#### **Addendum 151 – UN Regulation No. 152**

#### **Amendment 4**

Supplement 3 to the original version of the Regulation – Date of entry into force:  
30 September 2021

#### **Uniform provisions concerning the approval of motor vehicles with regard to the Advanced Emergency Braking System (AEBS) for M<sub>1</sub> and N<sub>1</sub> vehicles**

Figure 1

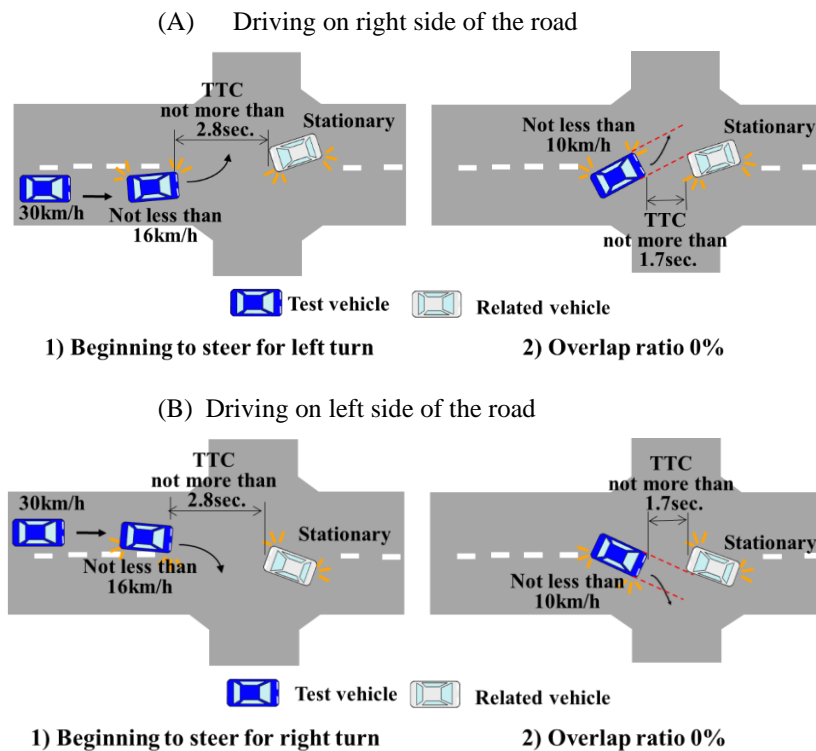
*Insert new Scenarios 1 to 4, to read:*

- 1.1. In this scenario, the subject vehicle passes by a left turn or right turn in front of an oncoming vehicle that is stopped to make a left turn or right turn at an intersection.

The subject vehicle drives at a speed of 30 km/h (with a tolerance of +0/-2 km/h) toward the intersection, and decelerates by braking to a speed of not less than 16 km/h at a point where the subject vehicle begins to steer left / right, and the Time To Collision (TTC) to the oncoming vehicle is not more than 2.8 seconds. When the subject vehicle turns left or right in the intersection, the speed is reduced to not less than 10 km/h, and then drives at a constant speed. The TTC to the oncoming vehicle is not more than 1.7 seconds at when the overlap ratio between the subject vehicle and the oncoming vehicle becomes 0 per cent.

Figure 2

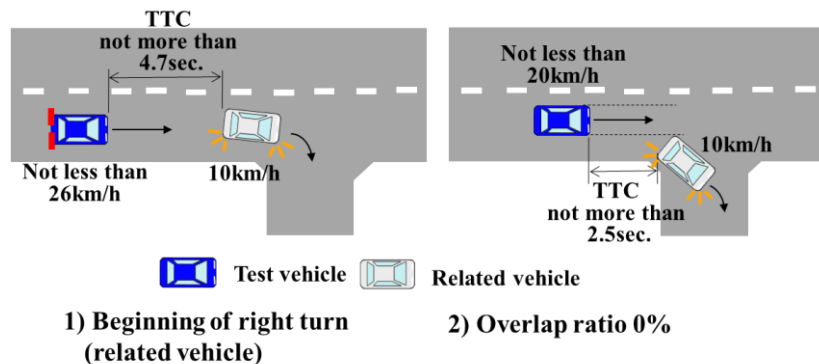
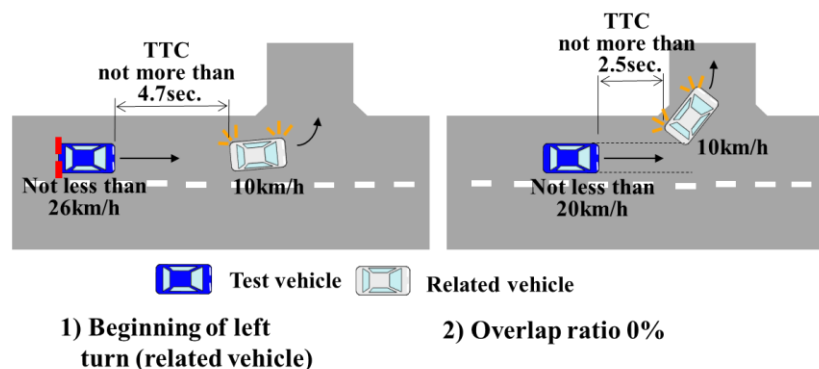
- 2.1. In this scenario, the subject vehicle follows a forward vehicle. After that, the forward vehicle turns right or left at a corner, and the subject vehicle goes straight.
- 2.2. An example of the detail scenario:

Both the forward vehicle and the subject vehicle drive at a speed of 40 km/h (with a tolerance of +0/-2 km/h) on the straight road. The forward vehicle decelerates by braking to a speed of 10 km/h (with a tolerance of +0/-2 km/h) in order to turn right or left at the corner, and the subject vehicle also decelerates by braking to keep appropriate distance with the forward vehicle. At when the forward vehicle begins to turn right or left, the speed of the subject vehicle is not less than 26 km/h and the TTC to the frontal vehicle is not more than 4.7 seconds. After that, the subject vehicle decelerates to a speed of not less than 20 km/h, and then drives at a constant speed. The TTC to the forward vehicle is not more than 2.5 seconds at when the overlap ratio between the subject vehicle and the forward vehicle becomes 0 per cent.

Figure 3  
Curved road with guard pipes and a stationary object

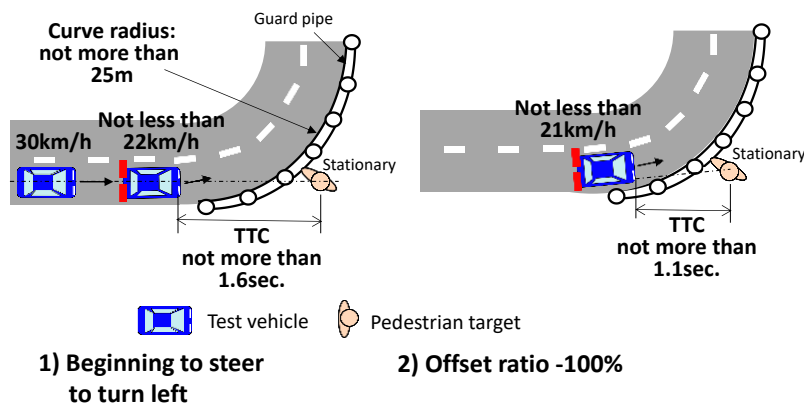
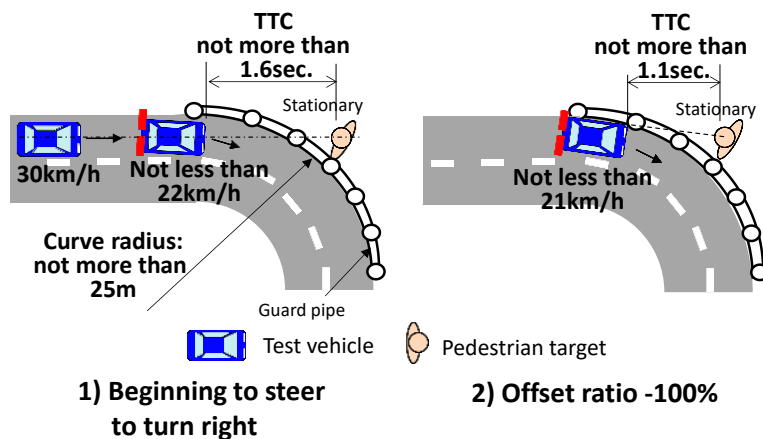
- 3.1. In this scenario, the subject vehicle drives a small radius curved road of which the guard pipes are constructed to the outer side, and a stationary vehicle (M<sub>1</sub> category), a stationary pedestrian target or a stationary bicycle target is positioned just outside of the guard pipes and where on the extension of the centre of the lane.
- 3.2. An example of the detail scenario:

The subject vehicle drives at a speed of 30 (with a tolerance of +0/-2 km/h) km/h toward the curve of which the radius is not more than 25 m at the outer side of the road, and decelerates by braking to a speed of not less than 22 km/h at a point where the subject vehicle enters the curve. The TTC to the stationary object is not more than 1.6 seconds at when the subject vehicle begins to turn in the curve. In the curve, the subject vehicle drives outer lane than the centre of the road. After that, the subject vehicle continue to turn in the curve at a constant speed of not less than 21 km/h. The TTC to the stationary object is not more than 1.1 second at when the overlap ratio between the subject vehicle and the stationary vehicle becomes 0 %, or at when the offset ratio between the subject vehicle and the centre of the stationary pedestrian target or the stationary bicycle target becomes -100 per cent.

Figure 4  
Lane change due to road construction

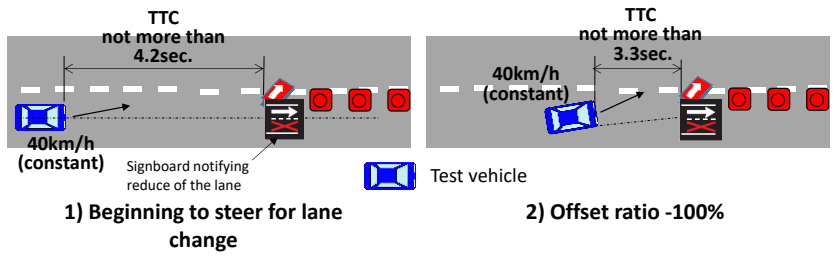
- 4.1. In this scenario, the subject vehicle changes the lane in front of the signboard which is positioned in the centre of the lane and notifies the driver that the lane is reduced.
- 4.2. An example of the detail scenario:

The subject vehicle drives a straight road at a speed of 40 km/h (with a tolerance of  $\pm 2$  km/h), and begins to steer in order to change the lane in front of the signboard which notifies reducing the lane. No other vehicles approach the subject vehicle. The TTC to the signboard is not more than 4.2 seconds at when the subject vehicle begins to steer. During changing the lane, the speed of the subject vehicle is constant, and the TTC to the signboard is not more than 3.3 seconds at when the offset ratio between the subject vehicle and the centre of the signboard becomes -100 per cent.
